Port Kembla Gas Terminal Proposed Modification

Submissions report

January 2020

Port Kembla Gas Terminal-Mod-1 (SSI-9471-Mod-1) Response to Submissions - Attachment 1

Figure 3-7: Fatality Risk Contours – High Demand Sensitivity F&G Detection & Isolation

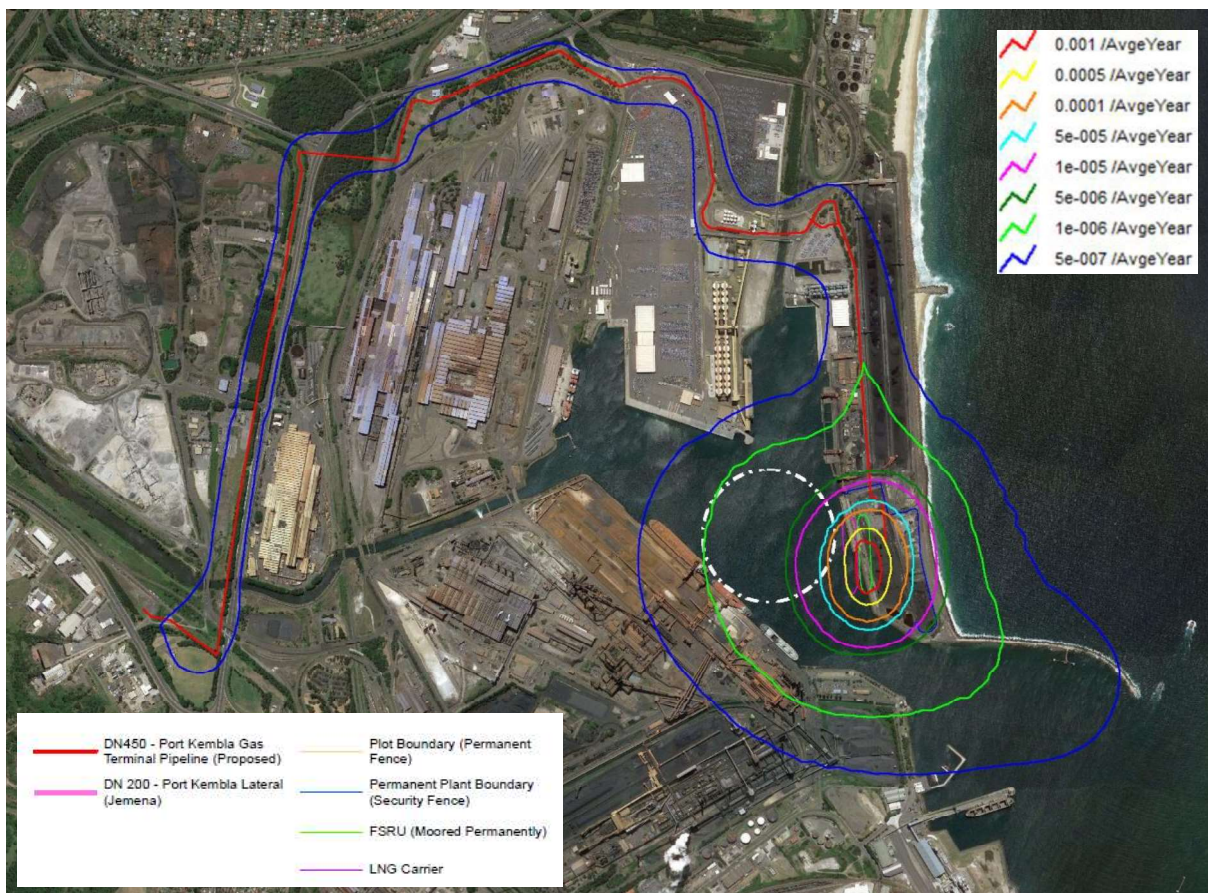
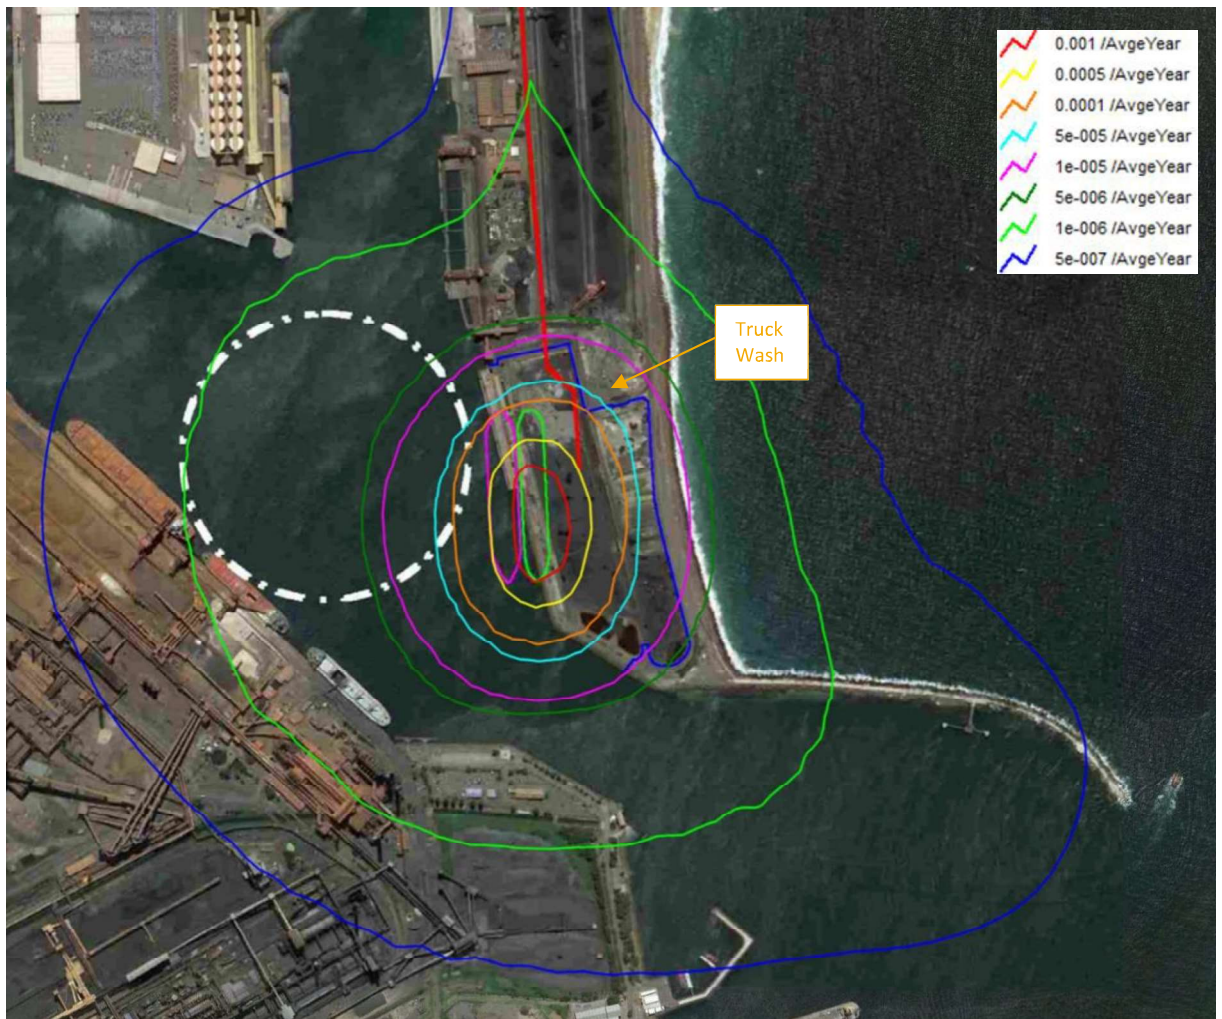
1f	Please provide a comparison table for the major risk contributors of the project, which includes the release inventory, peak release rate, the adopted average leak rate, the original IP, the mitigated IP, and any other reduction factors applied to the major risk contributors.	Risk model has been reran with a Risk Ranking Point at the Wharf to measure the top 10 risk contributors at this location. See table on the right. Table has been included in the Modification 1 Submissions Report.
1g	It appears that the E-Tree implies all release events will have some form of SIL 1 level isolation system. As such, a mitigated IP has been assumed for isolation successful scenarios for all events. This assumption seems to be optimistic and it depends on how the isolatable inventories are considered in the model. Please provide justification on whether this assumption is credible and revise the model if required.	The gas detection and isolation system only applies to the LNGC / FSRU and wharf topside equipment. The LNGC / FSRU cargo storage tanks and export pipeline are excluded due to large inventory sizes. Although it is noted that a SIL 1 F&G system is assumed, the base assumption is that 1 in 10 fire / gas incidents will not be detected and isolated. The detection can either be from BPCS, operator intervention and/or F&G system. The PFD set at 0.1 is in-line with typical PFD for BPCS or operator intervention (i.e. high stress situation), which is usually less reliable than a dedicated F&G system with PFD usually much lower than 0.1. Report (401010-01496-SR-TEN-0003) rewording in Section 3.2.3 modified.

By applying the above steps to reduce the ignition probability and isolatable volumes, accounting for SIL 1 F&G detection and isolation system, the resulting risk contours generated from the proposed 500 TJ/day increased production throughput and increased weekly LNGC deliveries were modelled and are presented in Figure 3-7 and Figure 3-8.

Comparing the sensitivity case in Figure 3-7 and Figure 3-8 to the High Demand Case in Figure 3-5 and Figure 3-6 the 5E-05 and 1E-05 risk contours have contracted. The 5E-05 pa risk contour for industrial areas extends slightly beyond the wharf fence line on the north-east boundary and does not impact the truck wash located in this area. Note further reduction in the contours may be realised through calculation of individual isolatable section volumes and applying these to the risk model.
